TO: All Dealers

BULLETIN: #T-62-10

SUBJECT: PLUNGER RETAINER (RACK & PINION ASSY.)TRIUMPH HERALD

BOSS TAPPING DETAILS.

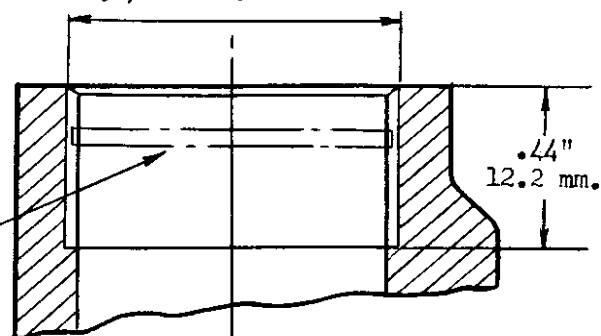
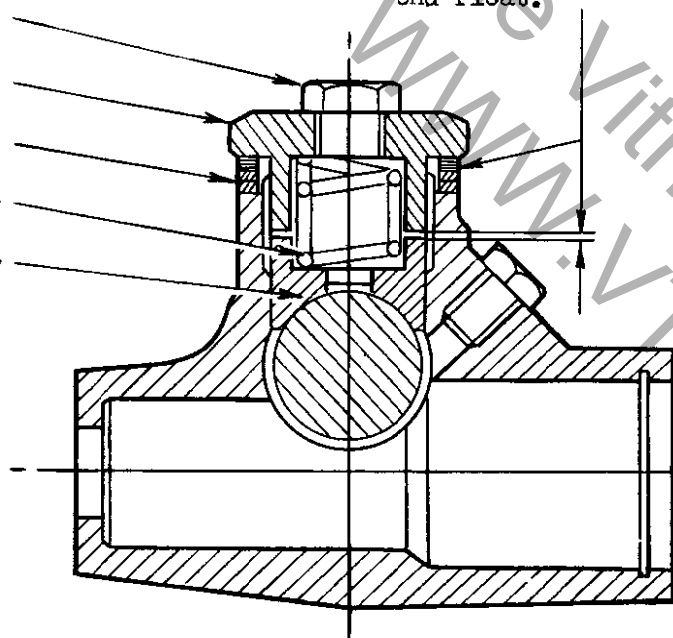
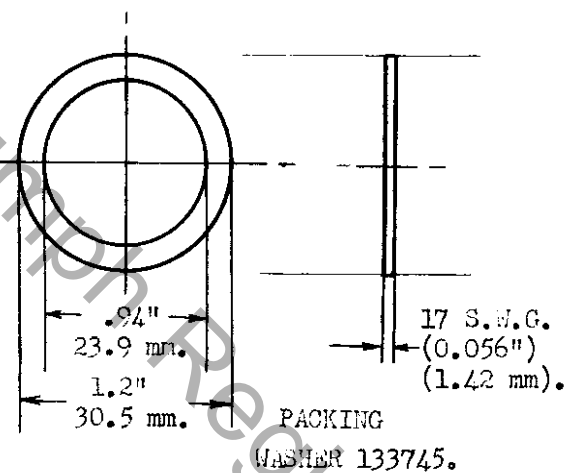
Some steering units incorporate a circlip and spring plate to retain the plunger in the rack and pinion assembly. Should circlip failure occur, modify the unit to the current screwed cap and spring method of retaining the plunger, as illustrated overleaf and described below:

This method of securing plunger may
be incorporated on Part Number 205628
and 304737 when serviced for complaint
of circlip not holding in position.

1. Remove and dismantle the steering unit as described in the Service Manual (Group 4).
2. Tap the plunger boss housing to a depth of $\sim .44"$ (12.2 mm). using a 15/16" UNF. 16 TPI tap.
3. Thoroughly clean the housing and pack with the correct grade of grease when refitting the rack and pinion.
4. Fit new plunger 120946; spring 126765; and screwed cap 132053; placing two packing washers 133745, and sufficient shims 120949 and 120959 between the cap and housing to obtain correct end float.

NOTE: The end float should be between $.004"$ to $.008"$ (0.1 to 0.2 mm) or the minimum amount consistent with free movement from lock to lock.

Use shims 120949 and 120959
as required to give 0.004" -
0.008" (0.1- 0.2 mm.) plunger
end float.

15¹¹/₁₆ UNF. 16 T.P.I.
